Hillrom™ Hillrom Luleå Nedre Vägen 100, 975 92 Luleå, Sweden	Field Safety Notice	 FA-2021-11-004-LUL-002
---	----------------------------	--

FSCA-identifier: FA-2021-11-004-LUL-002

Commercial name of the affected product,
Traverse Rail Carrier and Traverse Rail Carrier E-System, wide

Figure 1

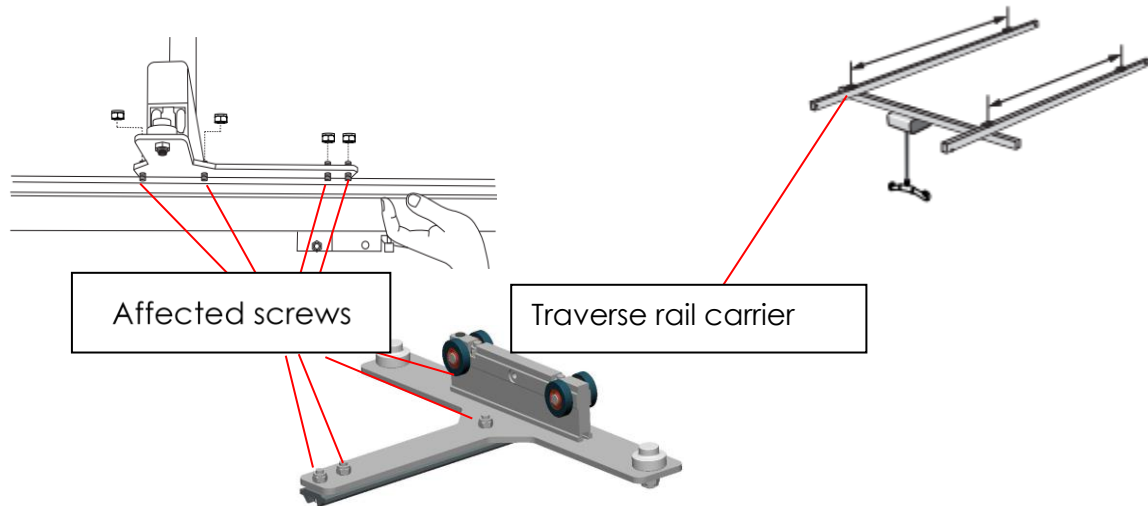
A traverse system consists of two primary rails with a secondary rail in-between. See figure 1 below.
